**Agenda Item 3**  
**1781 Knollwood**  
**New Single-Family Residence on a Vacant Lot**

## 1781 Knollwood Lane

**Continued consideration of a request for a recommendation in support of a new single-family residence on a vacant lot, tree removal, hardscape and landscape plans.**

### **Review of the Board Comments from the Last Meeting**

1 SITE PLAN  
NTS

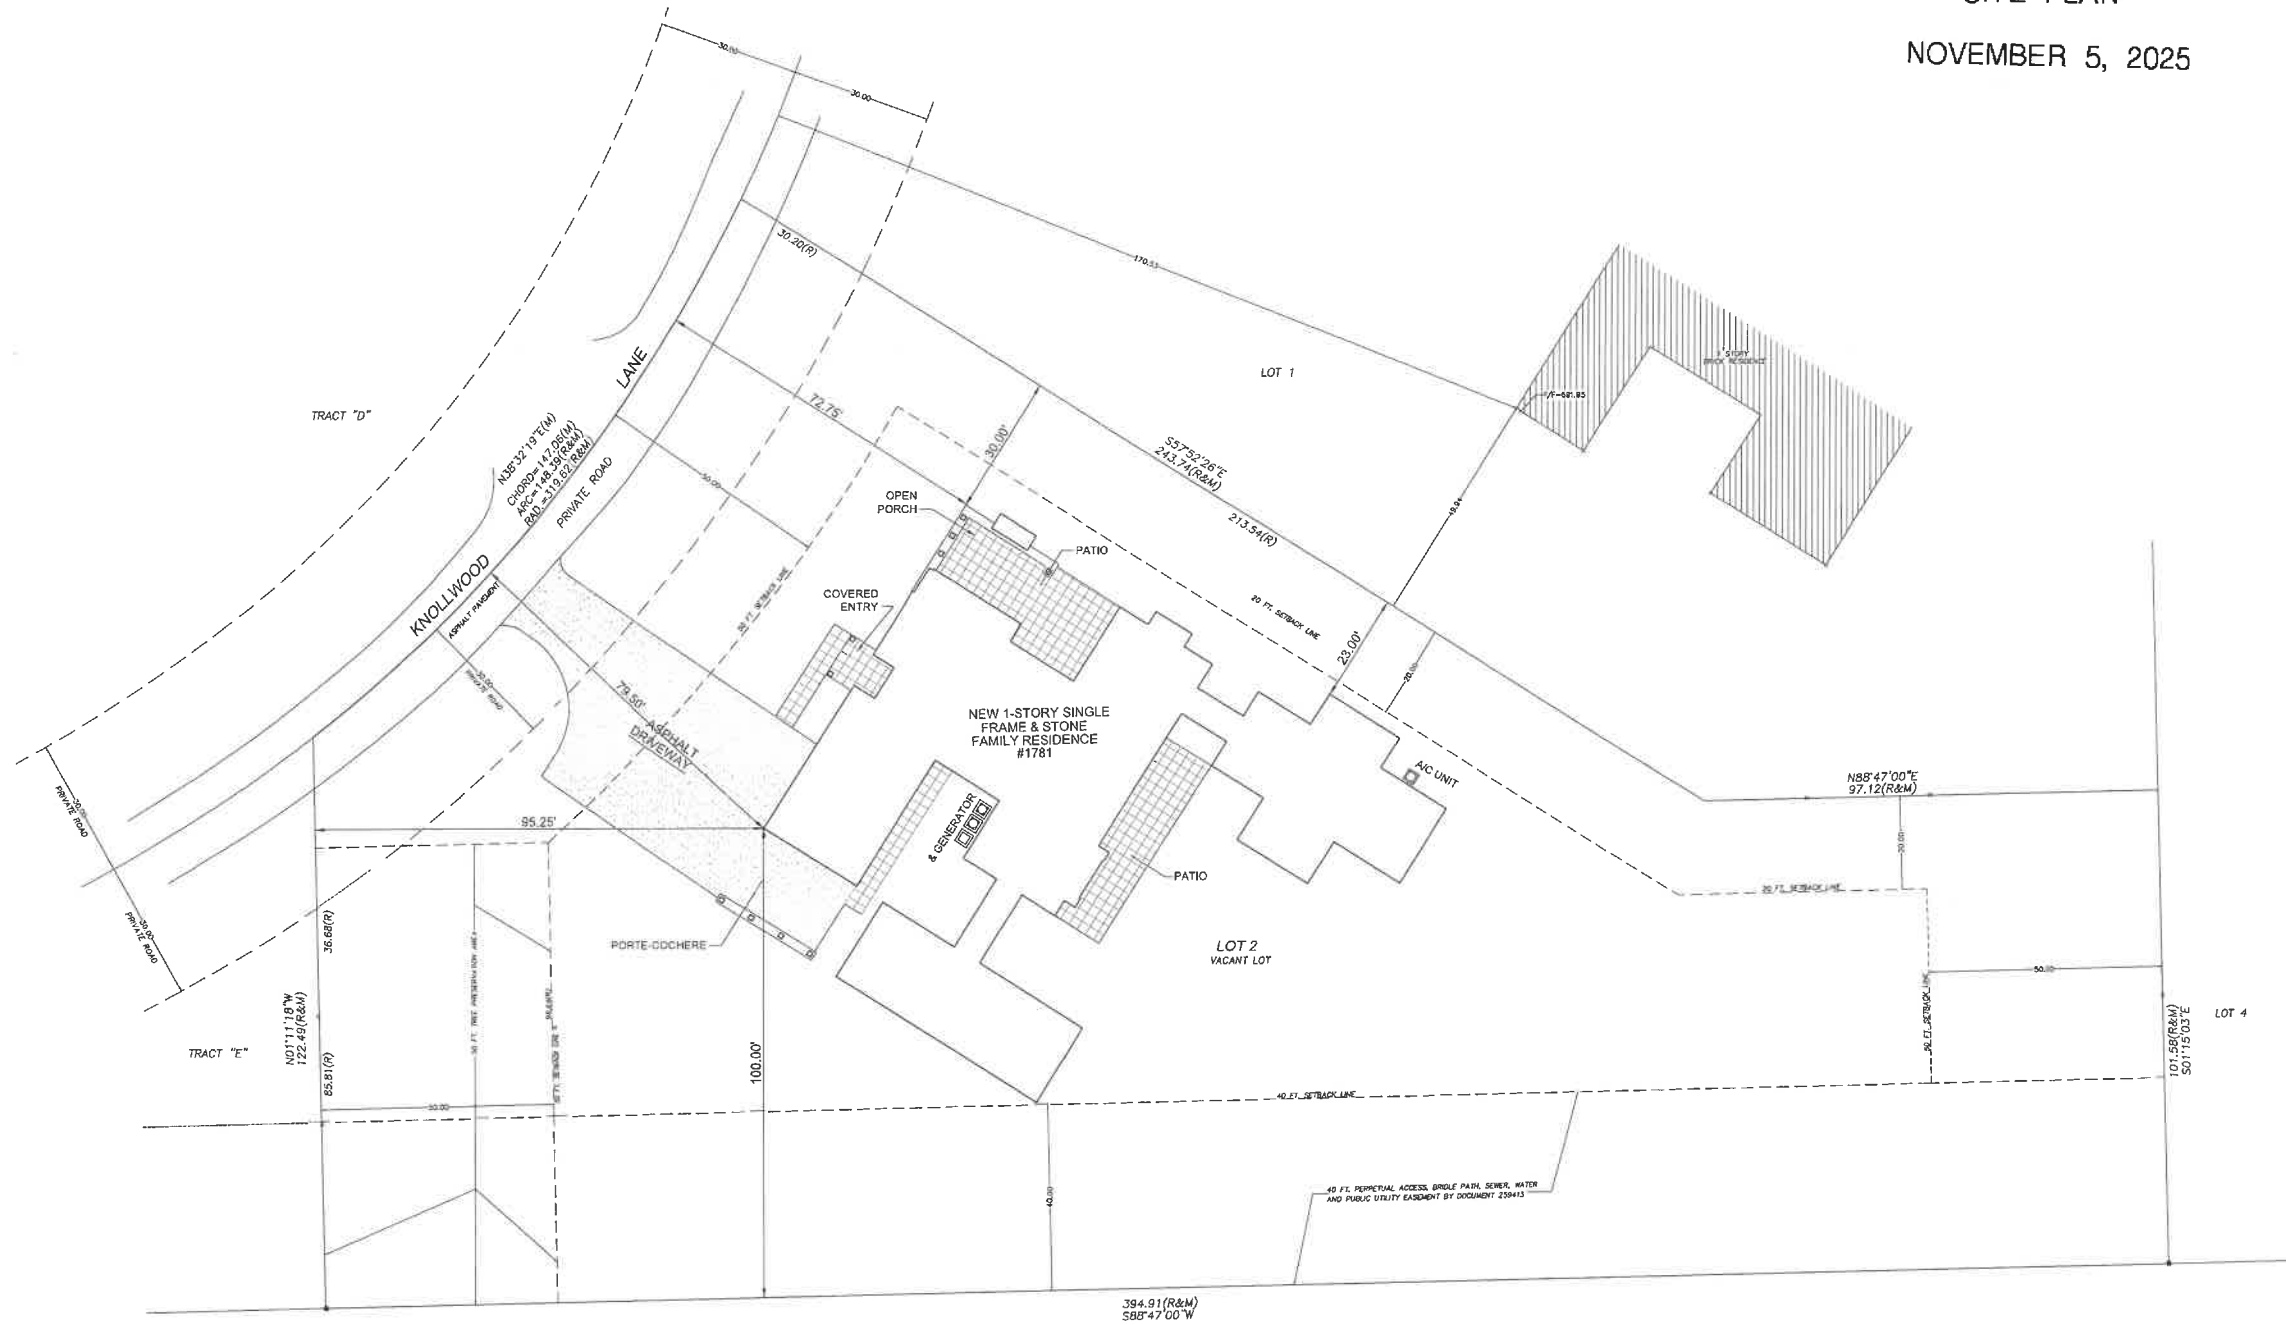
- a. Shift the house towards the south property line.  
**The house is shifted 2-3 feet to the south and is now sited at the side yard setback from the south.**

In response to comments and direction from the Board, the house is shifted to the south to the furthest extent possible, now sited at the side yard setback from the south. This new siting creates additional space between the proposed residence and the neighbor to the north, mitigating the sightlines from the rear yard of the neighboring property by allowing for additional landscape plantings.

In response to concerns regarding adequate space within the garage apron for cars to maneuver into and out of the garage, the garage apron is widened. However, the driveway within the front yard setback was also widened and will need to be adjusted to ensure that it does not exceed a width of 16 feet within the front yard setback. An auto turn study will be required along with the submittal for permit to demonstrate that there is adequate space to maneuver into and out of the garage.

Response: Proposed residence was moved towards the south lot line.

Response: Driveway study was completed - provided new driveway layout.

PROPOSED  
WEST AND NORTH ELEVATIONS  
NOVEMBER 5, 2025

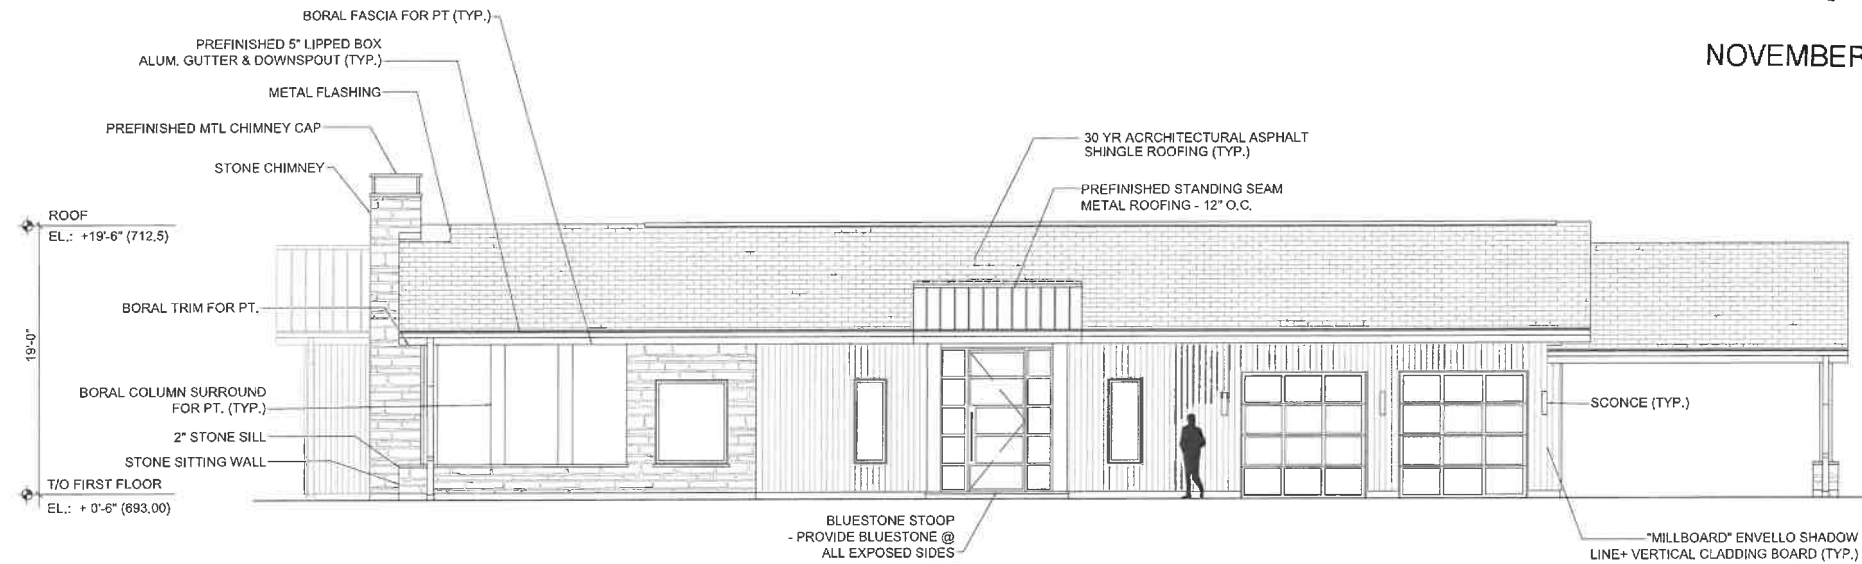
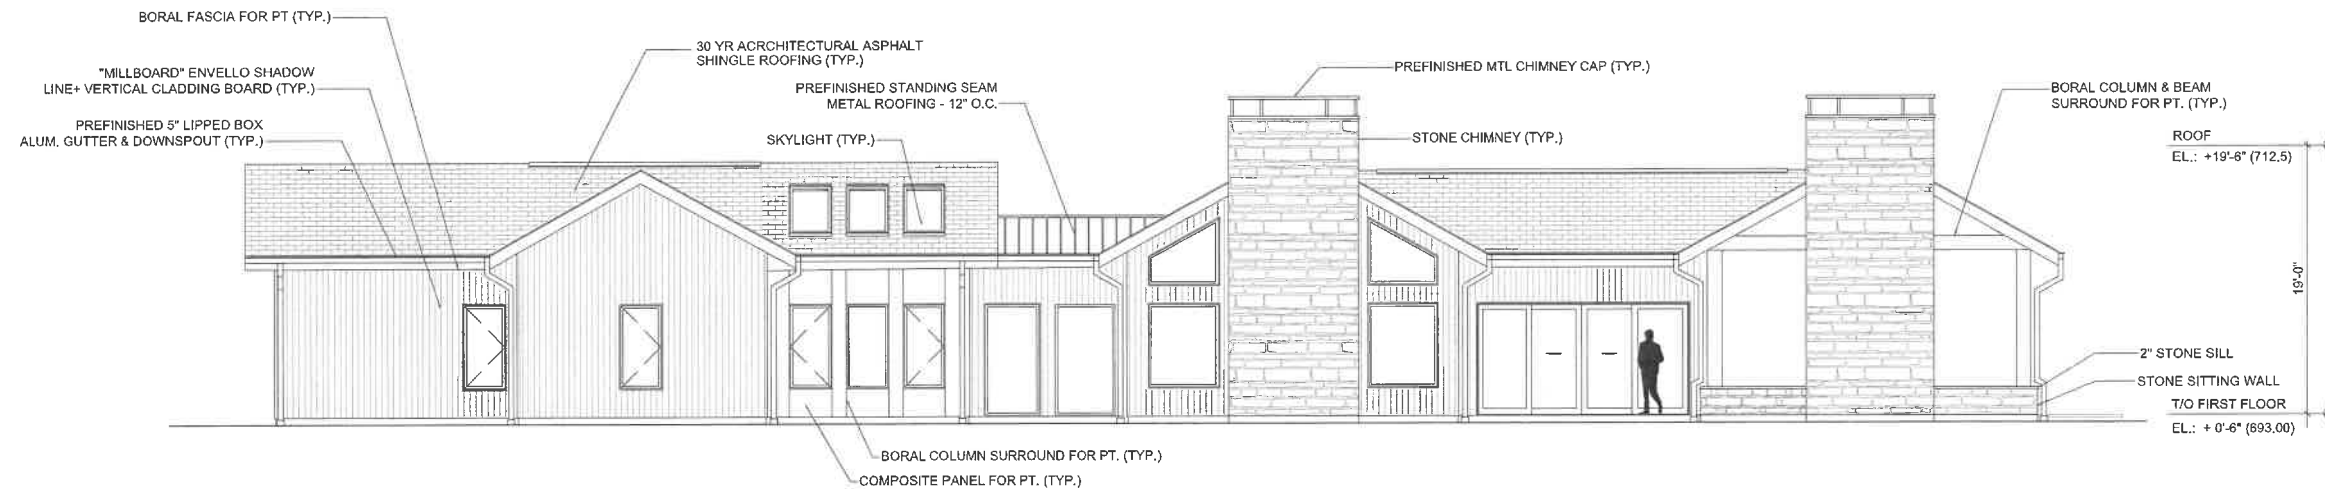
3. On the north elevation:
- a. Refine the front entrance.
    - i. Consider slanting the roof of the entrance.  
**The roof at the entrance is slanted.**

- ii. Consider lowering the height of the front door/entrance.  
**The height of the front entrance and front door is lower in the new design.**
  - b. Study and refine the port-cochere to appear less heavy.

In response to comments from the Board, the petitioner is making several changes to the original front elevation. The front door and front entrance are lower in height and the roof of the front entrance is slanted. The height of the porte-cochere is lower, the pillar to the left of the study is stone to match the pillar to the right, and the garage doors are no longer use glass. Together, these changes appear to respond to the direction provided by the Board.

Response: Roof canopy at entry was pitched to create a steeper slope.

Response: Entry canopy was lowered, entry door transom was eliminated.

# MATERIAL SAMPLES

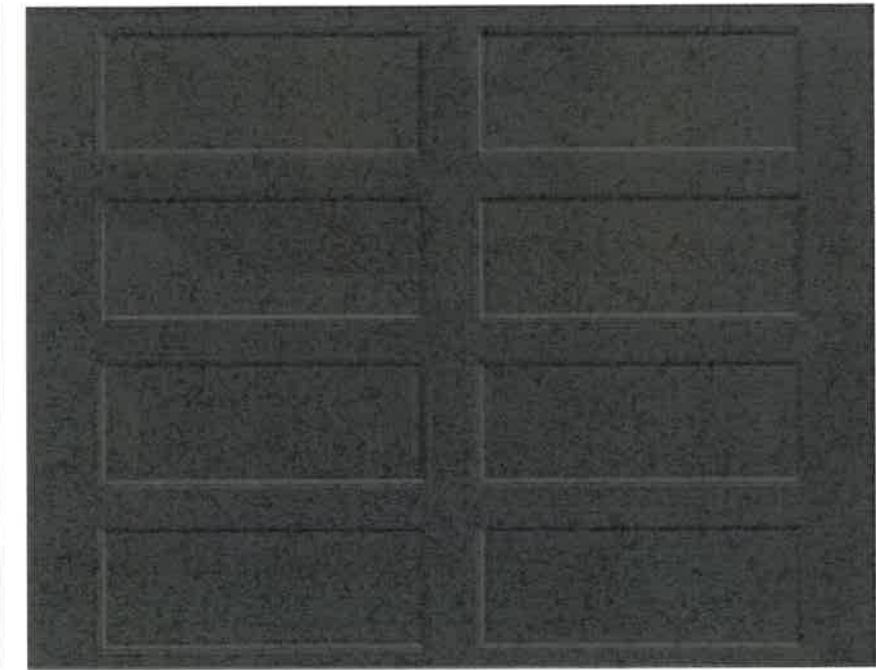
- i. Consider the use of wood garage doors, rather than glass.  
**The garage doors are now proposed as wood.**
4. Submit a basement plan.  
**The packet now includes a basement plan.**

Images of the proposed exterior materials are provided in the packet: roof material, 4-inch veneer stone, composite siding, and garage doors. In response to comments from the Board, the garage door design no longer contains glass.

Response: All glass was eliminated from the garage doors.
